LP Tank Wiring – Fuel Sender and Solenoid

Bulletin Type:	SRP	Publication Date:	December 2021
Bulletin #(s):	21-025	Make(s):	Jayco & Entegra
Job Code(s):	Repair for the #1 LP Tank Switch Relay should not exceed .25 hour	Model(s):	All 20A & 20T Ethos All 20A & 20T Swift
Flat Rate(s):	Repair for the #2 LP Tank Wiring should not exceed .25 hour	Model Year(s):	2021-2022

Incident:	LP Tank is full but showing empty on Vega Touch panel		
Affected Units:	2021-2022 Jayco Swift & 2021-2022 Entegra Ethos		
Parts List:	(4) CONNECTOR, 16-14GA WP BLU BUTT SPLICE NYLON SLEEVE SBB-1 (Purchase locally) (1) CONNECTOR, SPLICE 2 WIRE CLR PLSTC WAGO 10-20GA (Purchase locally)		
Misc. Tools & Supplies:	Wire Cutter/Strippers	½" Wrench	
	Wire Crimpers	½" Socket with Ratchet	
	Butane Torch	Phillips Screwdriver	
Parts Return Information:	N/A

Fig 3

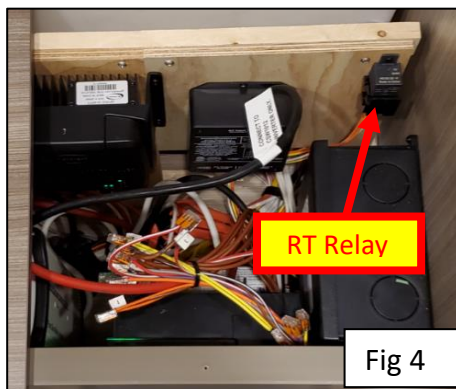
- A. Remove cushions from passenger side bed and set aside for installation later.
- B. Remove bed board from passenger side. Save the 7 fasteners for installation later.
 - i. **Note:** With the bed board fasteners removed, it needs to be moved forward to access wiring behind fuse block. (Figure 3)
- C. Remove the relay to gain access to the wiring
 - i. Relay for RT unit will be located behind the power center at the back of the bed shown in Figure 4.
 - ii. Relay for RA unit will be located behind the power center in the middle of the bed which is shown in Figure 5.

Fig 7

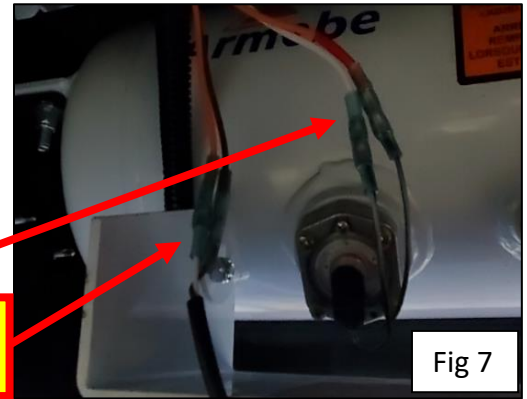
- A. Pull vehicle onto hoist and raise unit to a comfortable working height.
- B. Locate wire connections at LP Tank (Figure 7) and ensure they are wired:
 - i. Orange to Purple at Solenoid
 - ii. Brown to Black at Solenoid
 - iii. Orange w/Red Tape to Black at Gauge
 - iv. White to Black at Gauge

Electrical connections shown
installed incorrectly

- D. Re-connect wiring with 16-14GA Butt Splice Connector (Figure 9)
 - i. Orange to Black at Gauge
 - ii. Brown to Black at Gauge
 - iii. Orange w/Red Tape to Purple at Solenoid
 - iv. White to White at Solenoid
- E. Using a butane torch, heat shrink the 16-14GA Butt Splice Connector.
- F. Verify functionality by reviewing Firefly to ensure LP pressure is reading. If not, the gauge may have been damaged. If damaged, please contact your service representative for repair instructions and parts to replace.

Fig 8

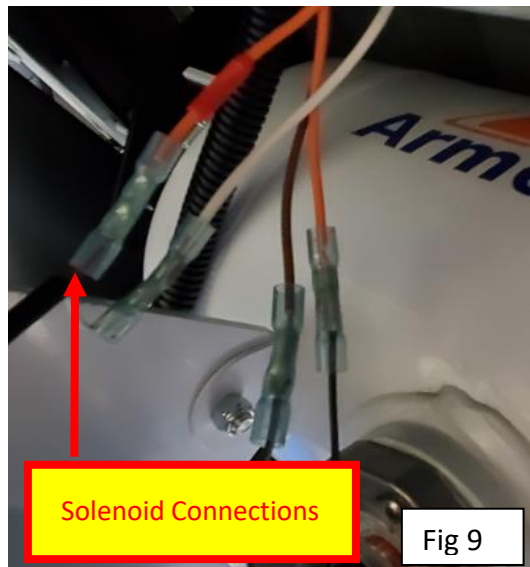
- C. Cut wiring and remove existing splice connector. (Figure 8)
